PRODUCT AWARENESS BULLETIN

FROM ROSENBAUER

BULLETIN NUMBER: 7002

DESCRIPTION: Foam Dual Tank Re-Fill System

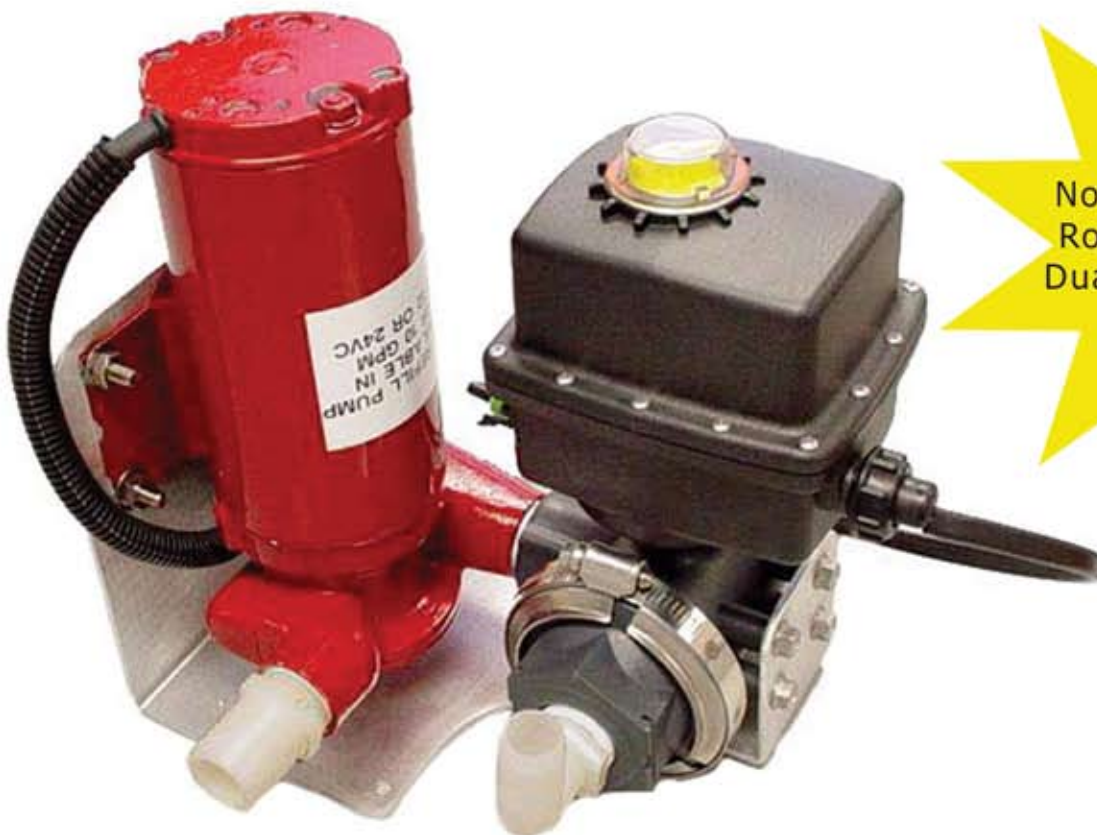
SPECIFICATION: A Hale EZ-Fill foam concentrate dual tank refill system shall be installed on the apparatus. The system shall permit refilling of the on-board A & B foam tanks from an outside foam container or cell. The system does not require the operator to climb to the top of the apparatus with foam buckets to access the foam tank fill tower.

The system shall include an integral 12 volt electric pump, pump control panel, positive displacement foam pump, piping from the panel to the foam tank and a means to flush the system after use.

An on-off switch with label shall be provided on the control panel. The inlet connection on the side of the apparatus shall permit use of an intake suction hose and shall be covered with a dust cap.
